**REMARKS**

Serial No. 10/813,169  
Reply to Office Action dated April 22, 2005

Docket No. INTEL-0062

FIG. 2

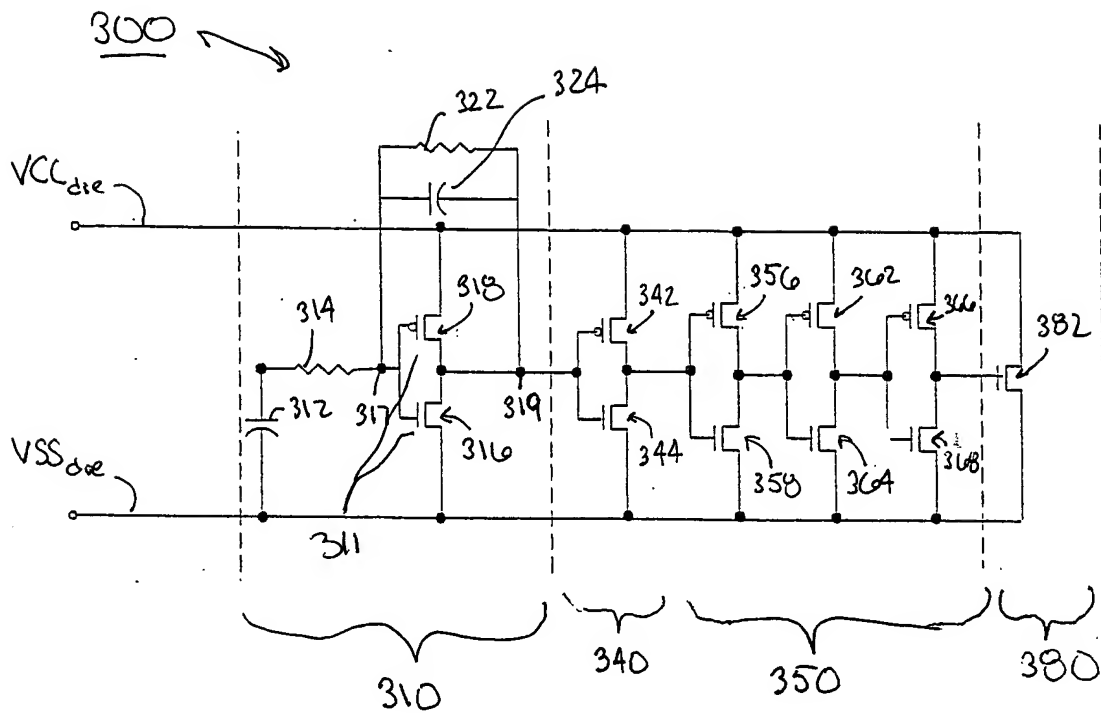
The Office Action questions how the recitation of “the band-pass filter including an operational amplifier and a comparator portion is read on the preferred embodiment.” Applicants respectfully submit that at least Figure 2 includes a band-pass filter 310 having an operational amplifier that may include transistors 316 and 318. See, for example, page 7, lines 14-16 of the present application. In order to further prosecution, this sentence is amended to label element 311 as the operational amplifier. Figure 2 is also amended to label the operational amplifier 311. No new matter is added.

The attached drawings include changes to Figs. 1-3. These sheets replace the original sheets. Each of replacement Figs. 1-3 is a formal drawing of the original drawings. In Figure 2, element 311 has been labeled. The specification has also been revised to correspond to this change.
